CITY OF FRANKLIN
PLAN COMMISSION MEETING*
FRANKLIN CITY HALL COUNCIL CHAMBERS
9229 W. LOOMIS ROAD, FRANKLIN, WISCONSIN
AGENDA
THURSDAY, DECEMBER 1, 2022, 7:00 P.M.

CITY OF FRANKLIN
REPORT TO THE PLAN COMMISSION
Meeting of December 1, 2022
Major Amendment to PDD No. 37

Project name:	M1 mixed use building, PDD Major Amendment to allow for ground floor apartments and 692-sf studio apartments
Property Owner:	Zim-Mar Properties, LLC
Applicant:	M1 at Ballpark Commons, LLC
Agent:	Emily C. Cialdini. Mandel Group, Inc.
Property Address/TKN:	SE corner of Rawson Ave and Ballpark Dr / 754 9006 000
Aldermanic District:	District 2
Zoning District:	PDD 37 – The Rock Sports Complex/Ballpark Commons
Staff Planner:	Régulo Martínez-Montilva, AICP, Principal Planner
Submittal date:	10-06-2022
Application number:	PPZ22-0162

Date: November 11, 2022
To: Emily Cialdini. Mandel Group, Inc.
From: Department of City Development
Régulo Martínez-Montilva, AICP, Principal Planner
RE: Staff comments for Major PDD Amendment, M1 Building at Ballpark Commons (BPC)
SE corner of Rawson Ave and Ballpark Dr / 754 9006 000

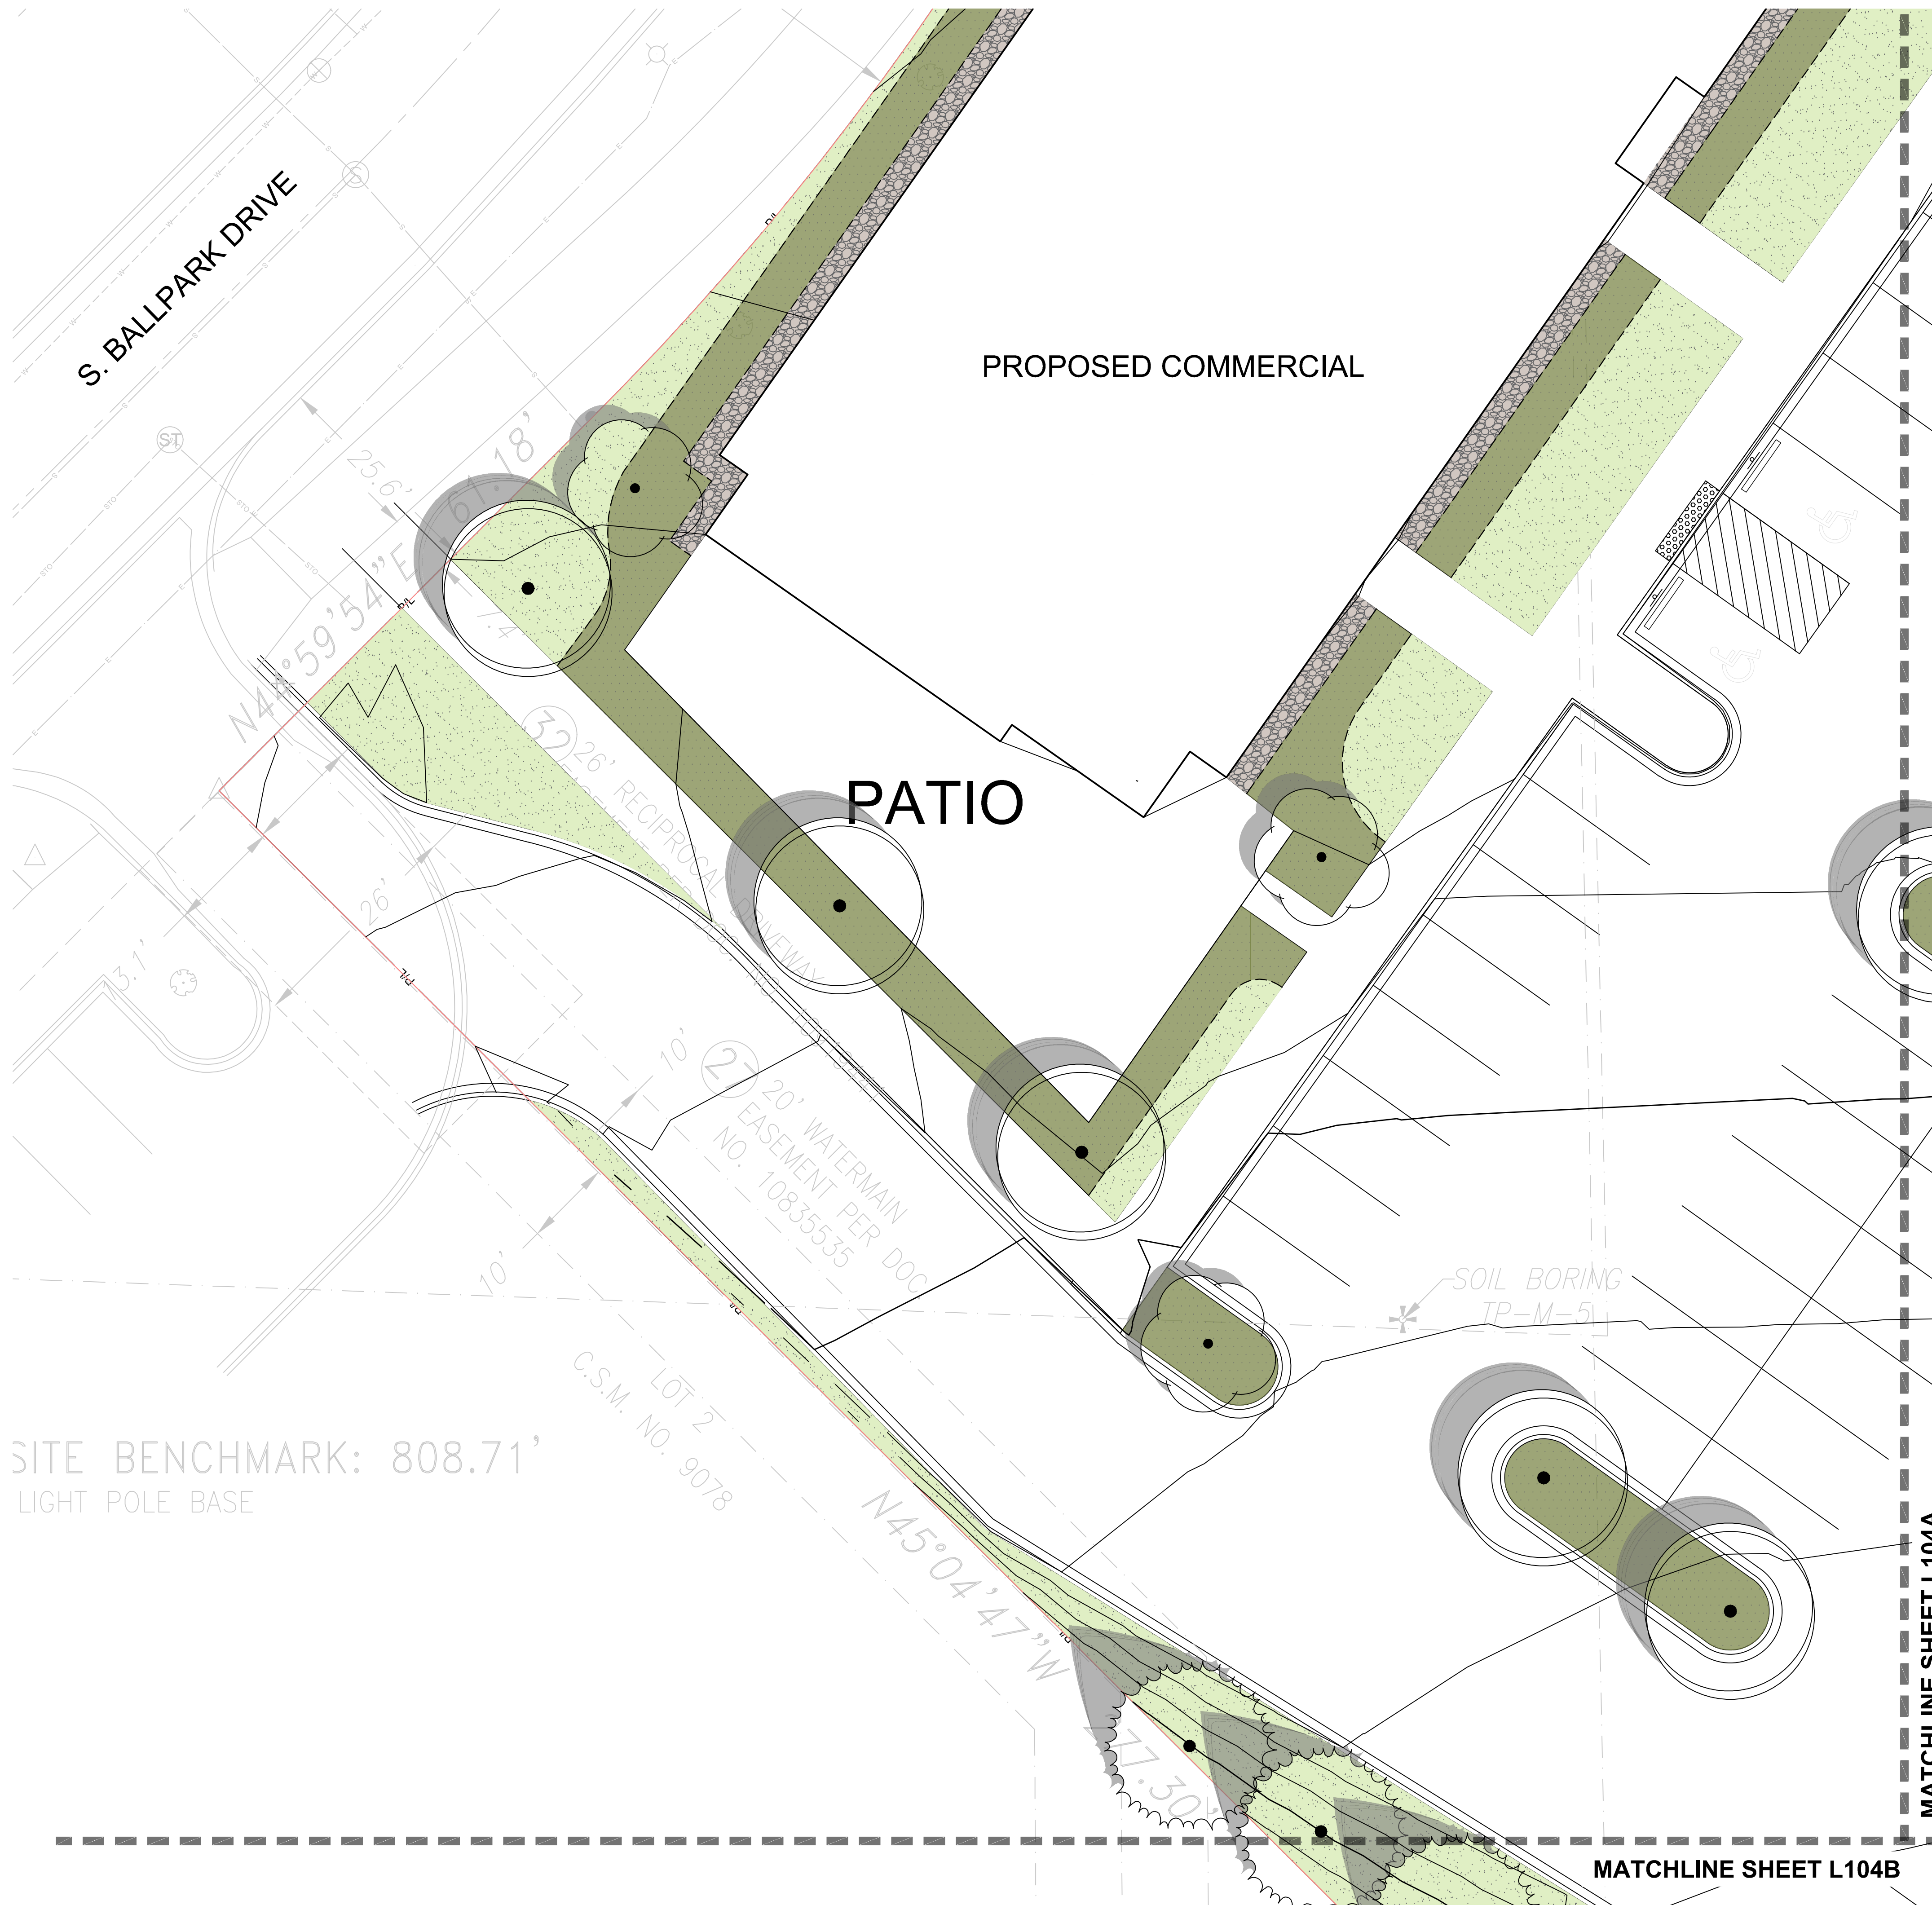
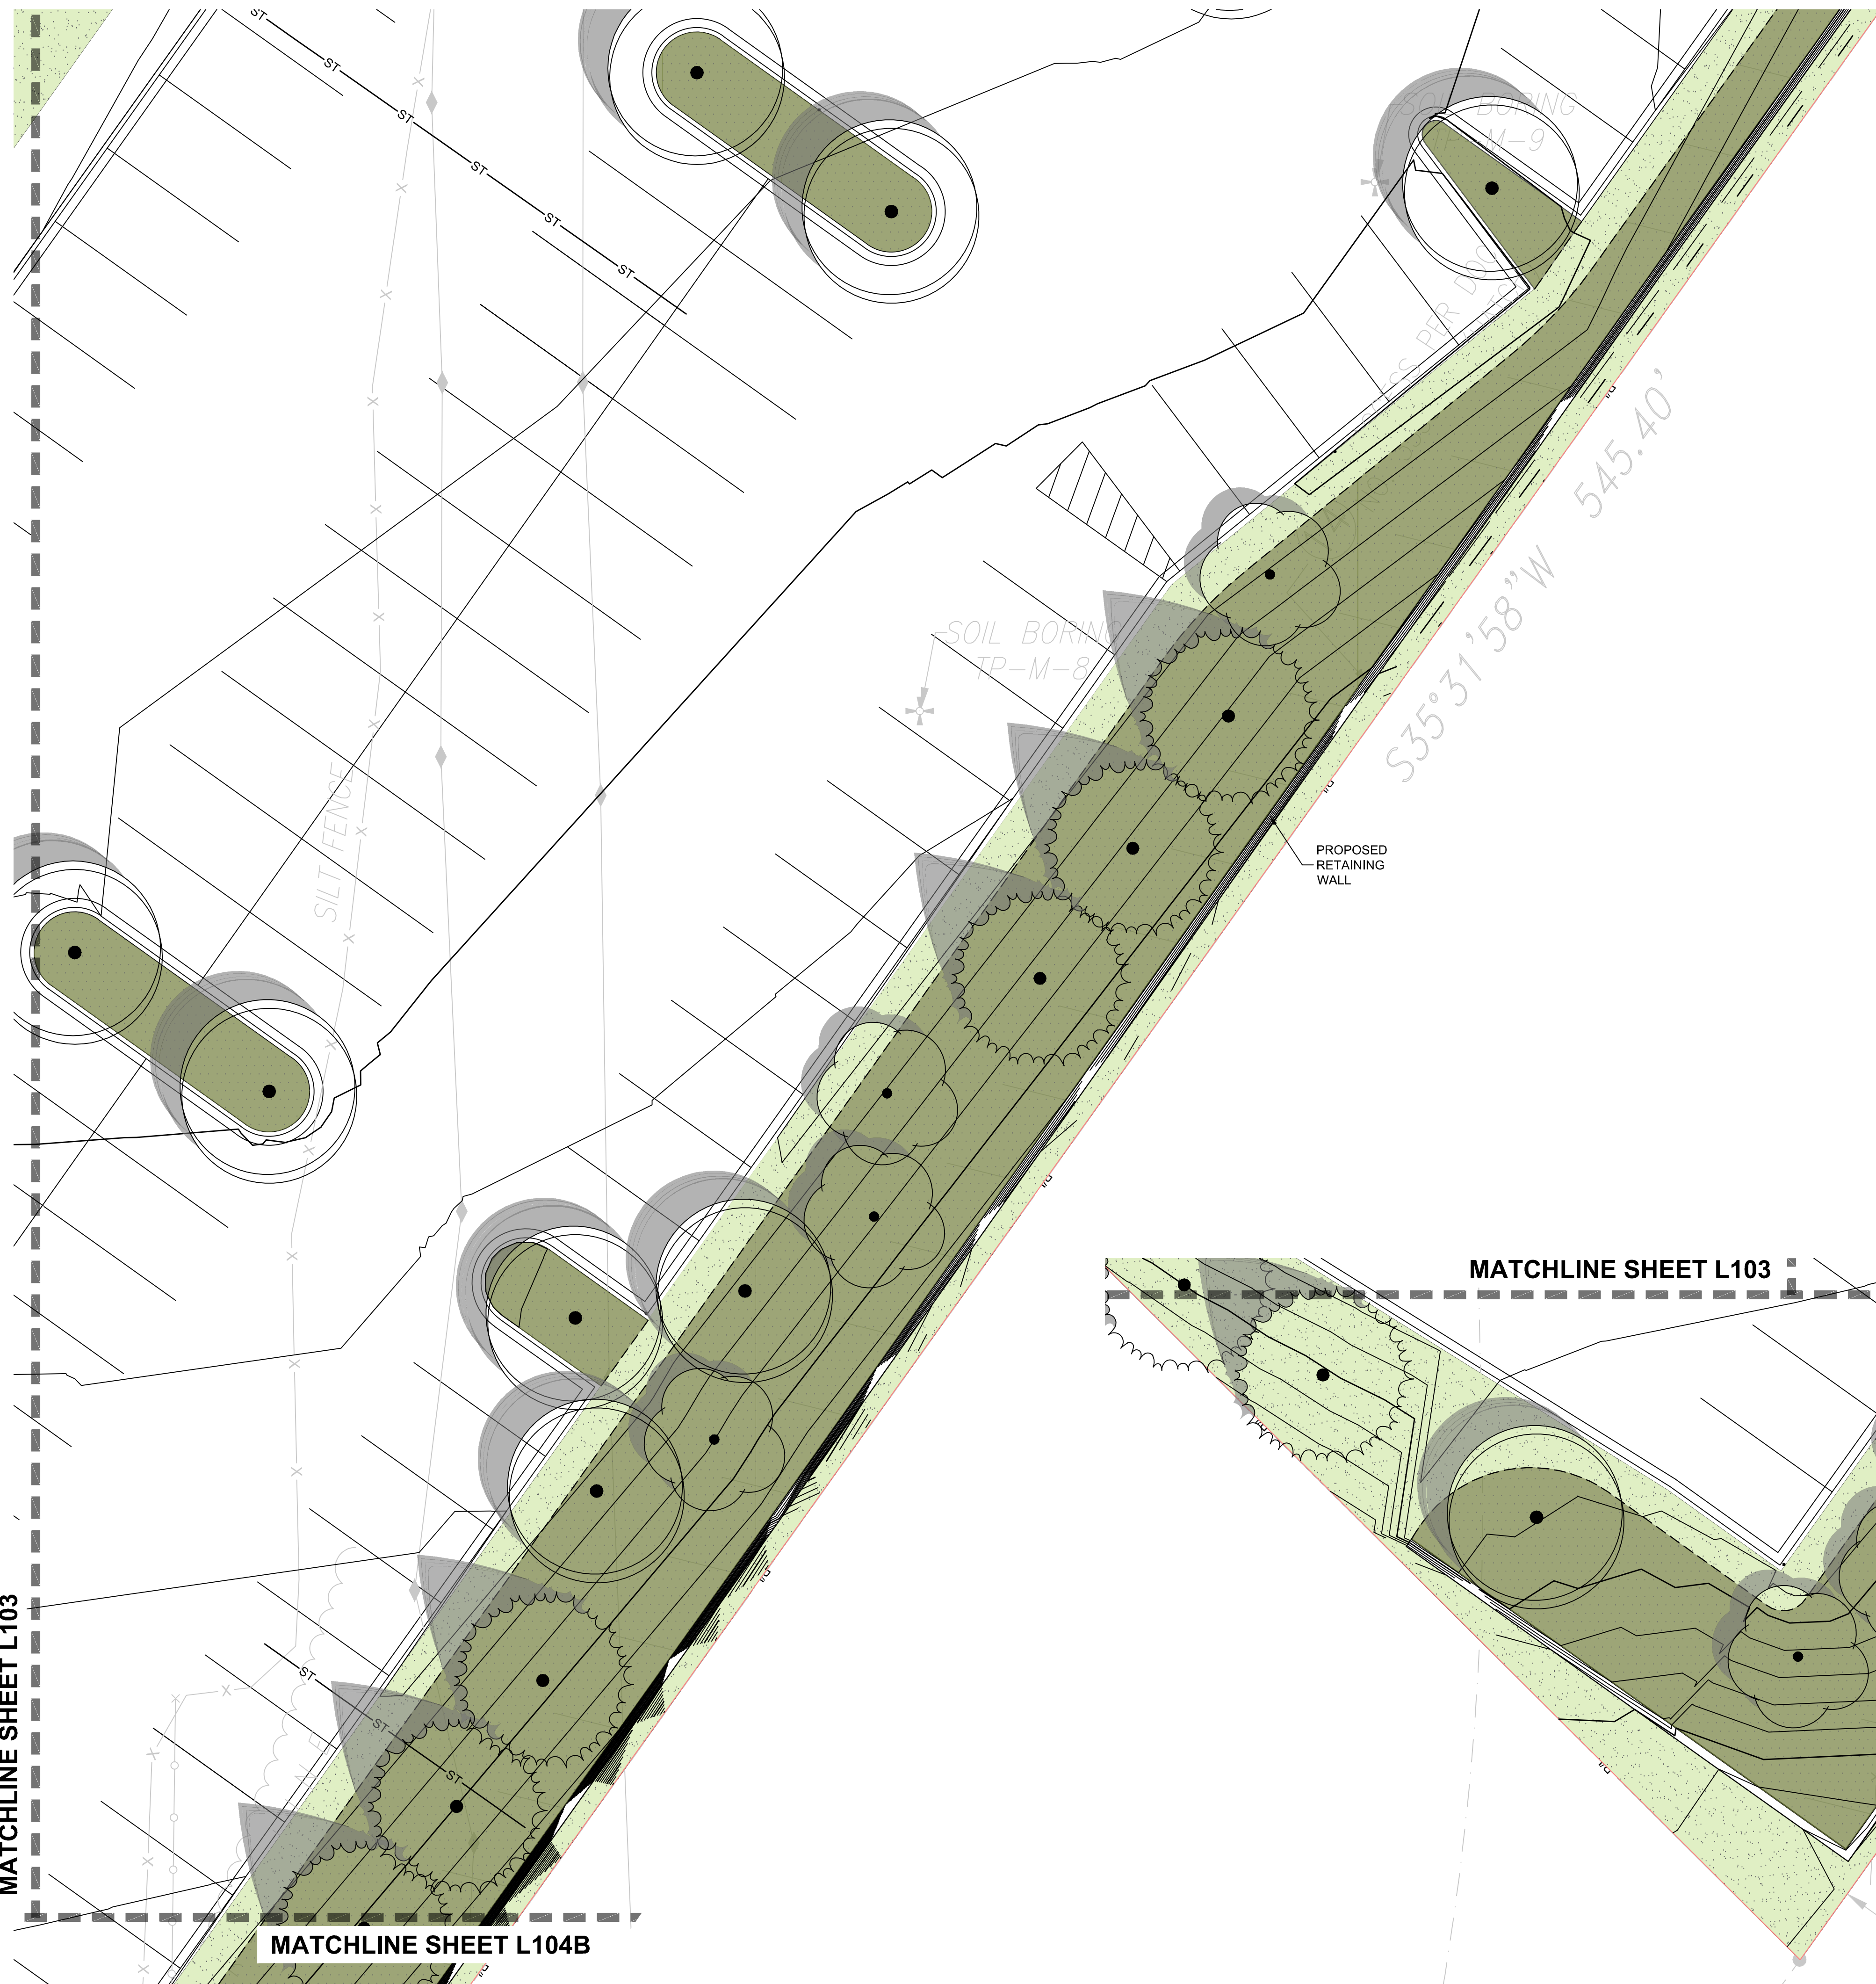
Staff comment: Along S. Ballpark Drive, ground floor commercial/retail/office uses will benefit from the proximity to the existing sidewalk. Along Rawson Avenue, a 30-foot landscape bufferyard runs along the entire frontage which creates a barrier between the proposed building and the existing sidewalk, so ground floor apartments are appropriate along Rawson Avenue due to the privacy and noise barrier effect of the landscape buffer (see landscape plan sheet L100).
